ARLINGTON AVENUE BRIDGES REPLACEMENT

Survey Response Summary

((March 1, 2021 – April 1, 2021))

Question 3:

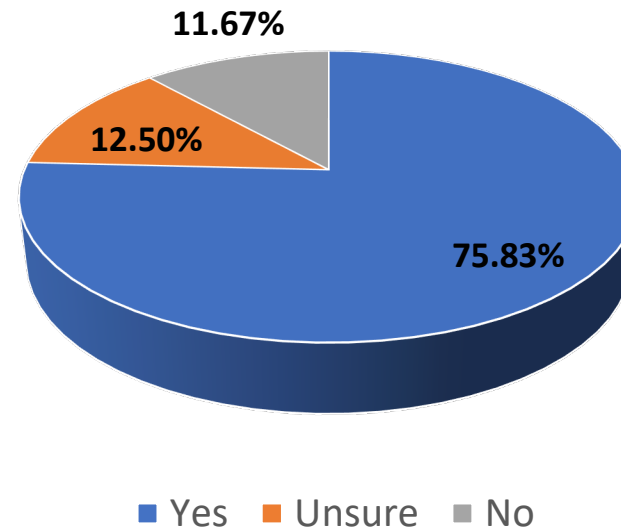
Question 3 Comment Themes

Support of using the tied arch concept (an eliminated alternative) which more aesthetically pleasing like the Virginia Street Bridge.

Concerned about the ability of the designs to accommodate debris and flow during flood events.

Question 5:

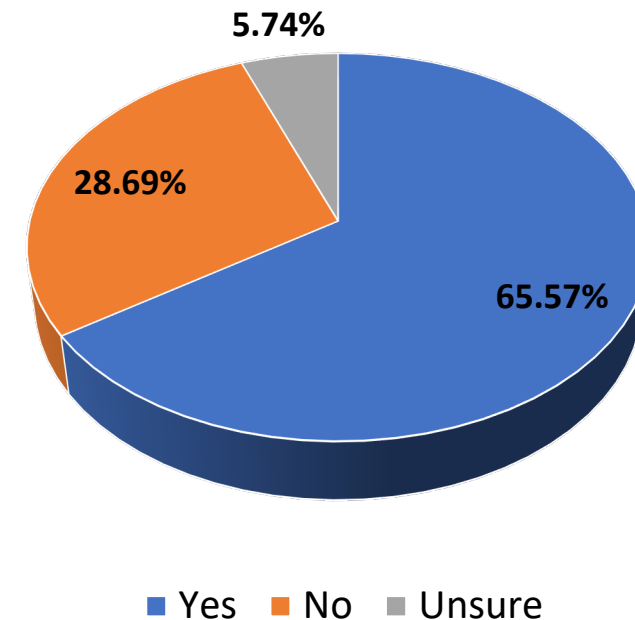
Question 5 Comment Themes

Concerns regarding the ability of the single pier design to accommodate debris and flow during flood events. Commenters see the pier as a future liability.

Commentors seem to favor the clear span for flooding concerns and aesthetics.

Concern about creating a place vagrants to frequently utilize.

Commenters are focused on providing pleasant pedestrian experiences, specifically, providing increased headroom.

Question 6:

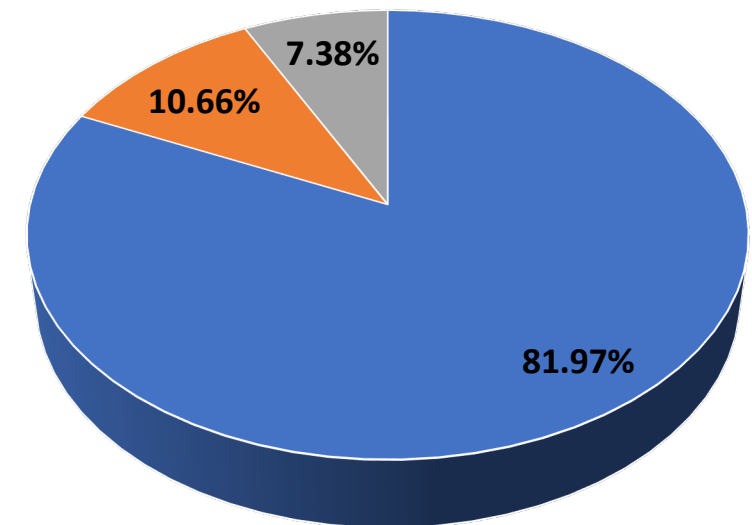
Question 6 Comment Themes

Design should be the same for all bridges.

The bridge's aesthetic feel should blend in with the surrounding area.

Ensure the bridge design can withstand flood events, would be easy to maintain, and are fiscally responsible.

Question 7:

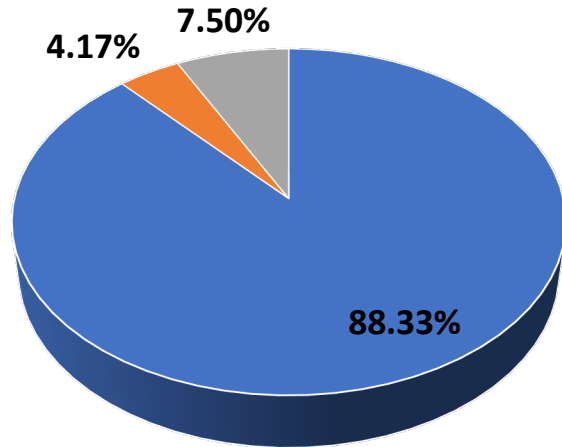
Question 7 Comment Themes

More lighting for safety.

Concerned about lighting impacts on wildlife and the river ecology.

Want to incorporate lighting that is aesthetically pleasing and follows dark sky certifications.

Question 8:

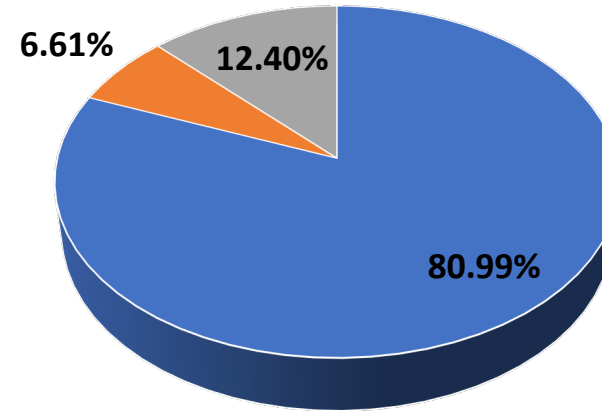
Question 8 Comment Themes

Commenters are in favor of accent lighting for safety and aesthetics.

While in favor, commenters do not want lighting that would contribute to light pollution.

Commenters voiced concerns about lighting impacts on wildlife and the river ecology.

Question 9:

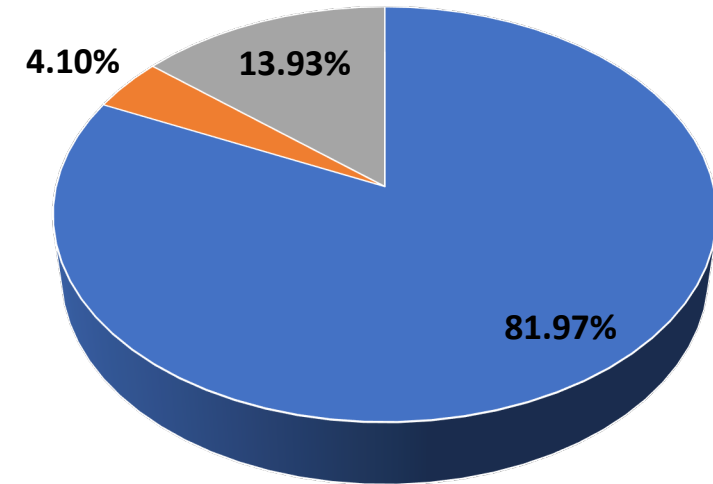
Question 9 Comment Themes

Of those who commented, about half want the access freedom the single railing would provide, especially during local events.

The opposing half of commentators would prefer double railing to provide increased safety to pedestrians.

Question 10:

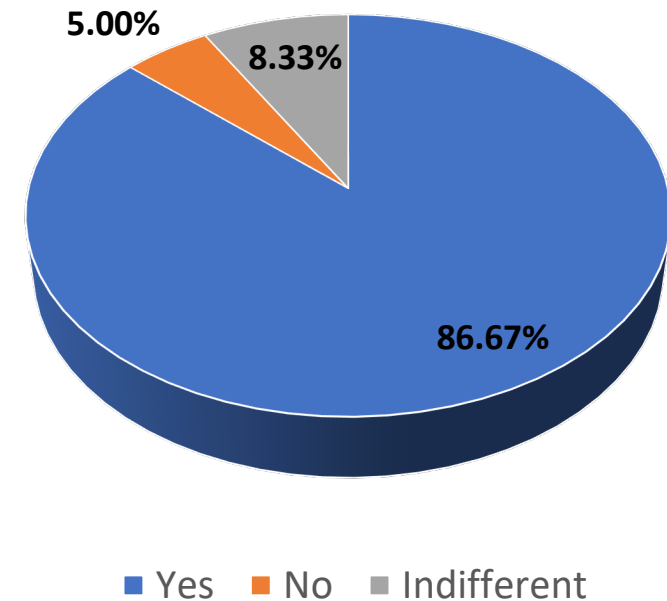
Question 10 Comment Themes

Some commentors are in favor or the metal railing as it better matches the aesthetics of the surrounding park and during local events.

Need to prioritize vehicle safety.

Want the selected railing to be flood friendly.

Question 11:

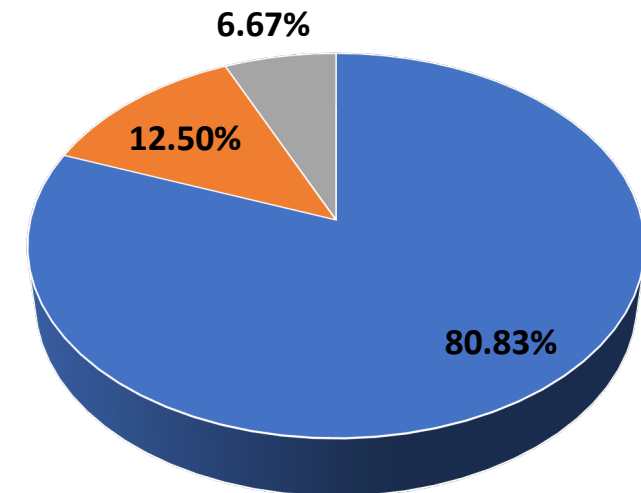
Question 11 Comment Themes

In favor of the wider sidewalks ONLY if it doesn't require a pier.

Not necessary, during local events the road is typically blocked for event and pedestrian use.

Wider sidewalks are standard in the downtown area and preferred by pedestrians.
